service bulletin

No. 95-10

MerCruiser MCM D7.3L/270 Diesel Stern Drive Replacement

a - Water Intake - 9 holes 94-95 M.Y.
b - Water Intake - 8 holes 1996 M.Y.

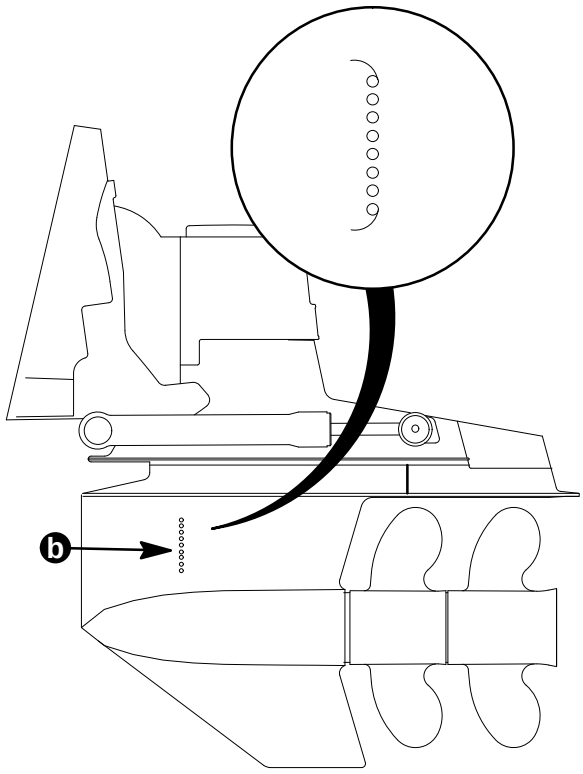
An overheat situation could develop if the D7.3L/270 diesel model engines are mated with a 1996 Bravo Three.

If replacing a 1994 or 1995 Bravo Three with a 1996 Bravo Three (all gear ratios) a thru hull water pick up kit (P/N 88845A2) is required to supply adequate water flow to the engine. The 1996 Bravo Three has an 8 hole water pick up, whereas the 1994 and 1995 Bravo Three had a 9 hole water pick up.
